Access Compliance Report Public Rights-of-Way (Curb Ramps)

Main Street: N/A Cross Street: CERRITOS_AVE Location: NW

ADA ID: RPAT220203145000 Ramp Type: Type 1 - Perpendicular Initial Pass/Fail: Fail Overall Compliance: No Severity Score: 15

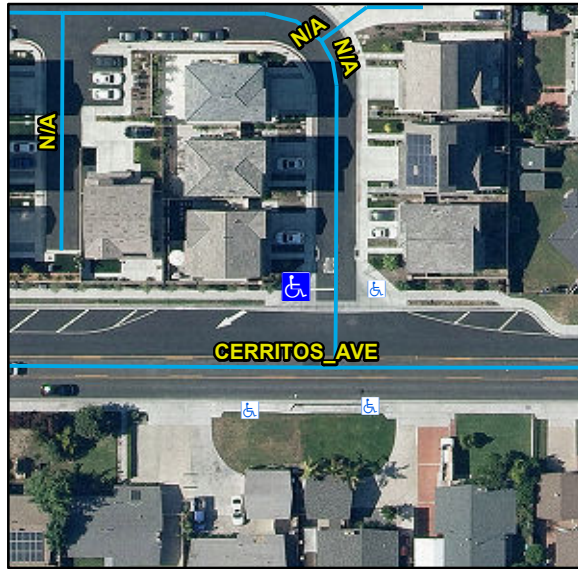
Compliance	Description	Data	Compliance	Description	Data
N/A	Ramp Length (in)	65	N/A	Flare Type LT	
Yes	Ramp Width (in)	48			N/A
No	Ramp Run Slope (%)	8.6	N/A	Flare Slope LT (%)	N/A
Yes	Ramp Cross Slope (%)	0.2	N/A	Flare Traversable LT	N/A
N/A	Landing Present	N/A	N/A	Flare Type RT	
N/A	Landing Length (in)	N/A			N/A
N/A	Landing Width (in)	N/A	N/A	Flare Slope RT (%)	N/A
N/A	Landing Run Slope (%)	N/A	N/A	Flare Traversable RT	N/A
N/A	Landing Cross Slope (%)	N/A	N/A	DWS Provided	N/A
N/A	Landing Movement Obstructed?	N/A	N/A	DWS Contrast	N/A
	Landing Movement Type	N/A	N/A	DWS Length (in)	N/A
N/A	Landing Shared	N/A	N/A	DWS Full Width	N/A
N/A	Clear Space	N/A	N/A	DWS Offset Left (in)	N/A
N/A	Clear Space To Crosswalk (in)	N/A	N/A	DWS Offset Right (in)	N/A
N/A	Marked Crosswalk 1	No	N/A	Marked Crosswalk 2	N/A
	Crossing 1 Direction	E		Crossing 2 Direction	N/A
	Marked Crosswalk 1 Width (in)	N/A		Marked Crosswalk 2 Width (in)	N/A

N/A	Ramp Inside Crosswalk 1	N/A	Yes	Ramp Inside Crosswalk 2	N/A
	Crossing 1 Slope (%)	0.7		Crossing 2 Slope (%)	N/A
	Crossing 1 Cross Slope (%)	1.3		Crossing 2 Cross Slope (%)	N/A
N/A	Gutter Ponding	N/A	No	Curb Slope	6.2
Yes	Gutter Lip Height (in)	0		Road Run Slope (%)	N/A
N/A	Gutter Run Slope (%)	N/A		Road Cross Slope (%)	N/A
N/A	Gutter Cross Slope (%)	N/A			
Yes	Overall Surface Condition: Acceptable		Yes	Perp Joint Present	Yes
	Cross Gutter Present?	Yes		Spandrel Present?	Yes
	Replace Cross Gutter?	No		Replace Spandrel?	No

Remove & Replace Entire Ramp.

R304.2.2, STD 1115
